# UNITED STATES PATENT AND TRADEMARK OFFICE

APPLICATION NO.	FILING DATE	FIRST NAMED INVENTOR	ATTORNEY DOCKET NO.	CONFIRMATION NO.
10/809,304	03/24/2004	Wenman Li	yeh-pt008	6519

# Office Action Summary

## DETAILED ACTION

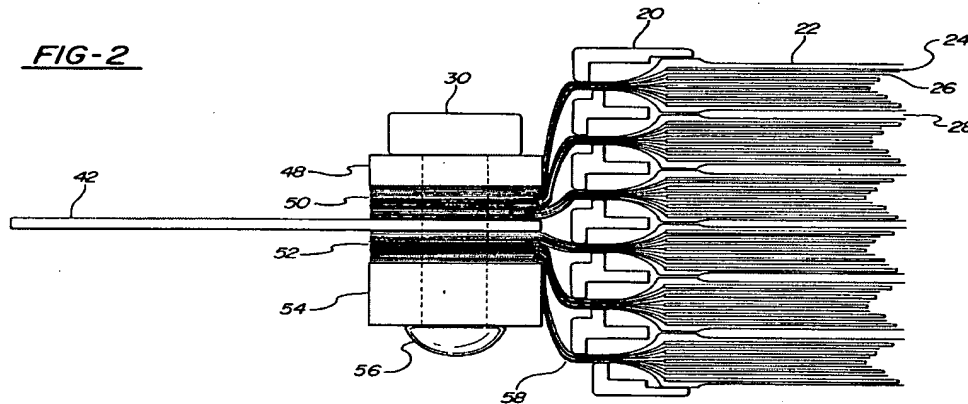
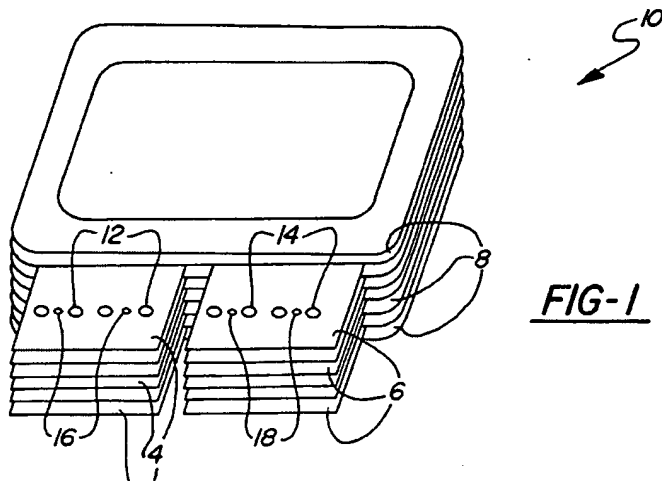
Tura et al disclose a method of tab bussing for a multicell battery (COL 1, lines 65-67 & lines 5-10/ CLAIM 1) wherein each cell includes an anode, a cathode and an electrolyte separating the anode and the cathode (*the stacked anode/membrane/cathode*), and at least one tab with at least one hole therein (*the punched current collector*); the battery includes at least one holding device such as rivets 30 passing through a hole in a tab of each cell and is secured to the tabs (Col 2, lines 15-20/ COL 3, lines 15-25/FIGURES 1-2) which is then connected to terminal 42 (*the lead*).

The method comprises a step of forming at least one hole through a tab of each individual cell, and inserting into a hole in a tab of each cell a holding device and securing the holding device to the tabs (COL 2, lines 1-5/ FIGURES 1-2). Tura et al discloses the method of tab bussing includes forming holding holes in the anode/cathode tabs and in terminal 42 by drilling or stamping (COL 4, lines 9-20) and the step of aligning these features (COL 4, lines 15-32); and the step of inserting into the hole formed therethrough first/second holding devices (Claim 1).

**Figures 1-2** above illustrate the use of multiple holding devices associated with a single tab (CLAIM 1). Thus, the requirement of varying the number of rivets and points of riveting is met because: 1) such a limitation is not recited in a positive manner (i.e. "may vary") so that a clear number of rivets and points of riveting is set forth therein. The language "may vary" has been interpreted as an optional step; or 2) the prior art uses at least more than one (1) bolt (rivet) for connecting current collectors. Thus, the prior art at once envisages using a number of rivets and points of rivet other than just one.

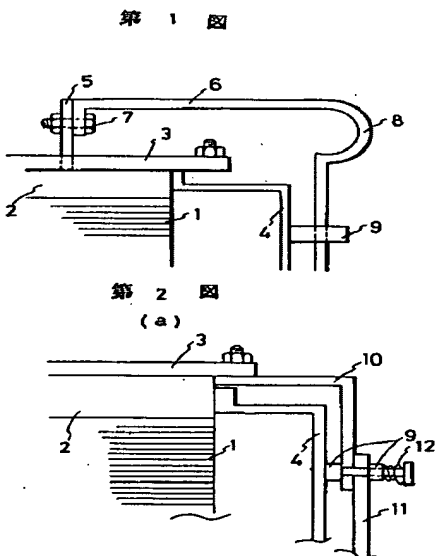
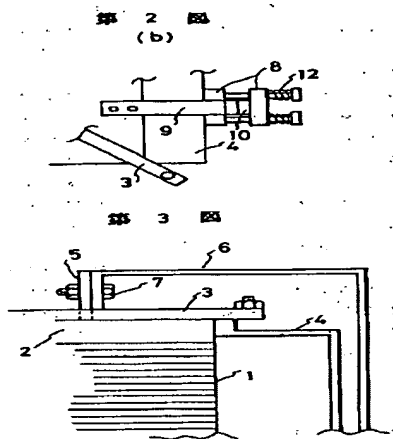
**Figures 1-2** below of JP'376 clearly illustrate a laminated cell comprising a matrix for holding electrolyte and gas diffusion electrodes (ABSTRACT/CONSTITUTION) and current collector plates 2 (*first and second current collector plates connecting electrode of multiple cells*) mounted on the top and bottom faces of the cell and clamped with a metal clamping fitting 3, and a bus bar 6 (*the leads*) is fixedly mounted on a current lead terminal 5 projecting from the current collector plate 2 by making use of a clamping bolt 7 (*the rivets*) (Abstract/Constitution).

**Examiner's note:** the JP '376 explicitly discloses all the features mentioned above. As such, the JP '376 must implicitly disclose a method of assembling all of the above features comprising the steps of alternately stacking electrodes and an electrolyte matrix to form a cell; and aligning punched lead terminals 5 which are then fastened to a bus bar 6 (the lead) by using a bolt 7 (the rivet).

**Figures 1-2** above illustrate the use of multiple bolts associated with a single current collector. Thus, the requirement of varying the number of rivets and points of riveting is met because: 1) such a limitation is not recited in a positive manner (i.e. "may vary") so that a clear number of rivets and points of riveting is set forth therein. The language "may vary" has been interpreted as an optional step; or 2) the prior art uses at least more than one (1) bolt (rivet) for connecting current collectors. Thus, the prior art at once envisages using a number of rivets and points of rivet other than just one.
